J&J Amusements, Inc.
4897 Indian School Rd NE
Salem OR 97305
U.S.A
Phone: 1-503-304-8899
Website: www.jjamusements.com
E-mail: info@jjamusements.com

Bulletin No: 22KARTGUARDBODY
Release Date: 10/1/2022
Effective Date: 10/1/2022
Supersedes: N/A
Supplement: 11KARTHAIRBODY
Completion Date: See text
Page: 1 of 1

Ride Name: Go-Kart

Model: Sidewinder, Sidewinder Double, Scorpion, King Scorpion, Can Am, Sidekick
(Honda GX-240 & GX-270 engines only).

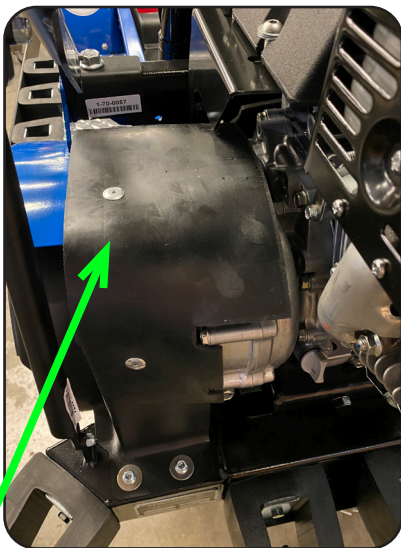
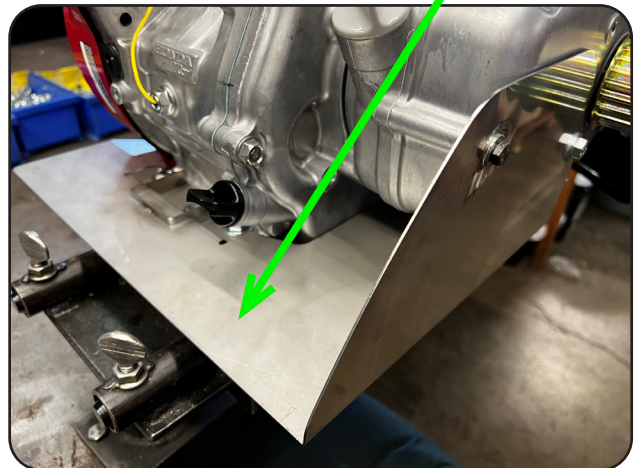
Installation of the axle drive cover guard and the engine guard assemblies to be performed by the owner at the owners expense.

To reduce the risk of unrestrained long hair or loose clothing becoming entangled in rotating parts.

Installation of J&J engine guard assembly and axle drive cover guard assembly.

Engine guard assembly part # 1-61-A0013

Axle drive cover guard assembly part # 1-60-A3020
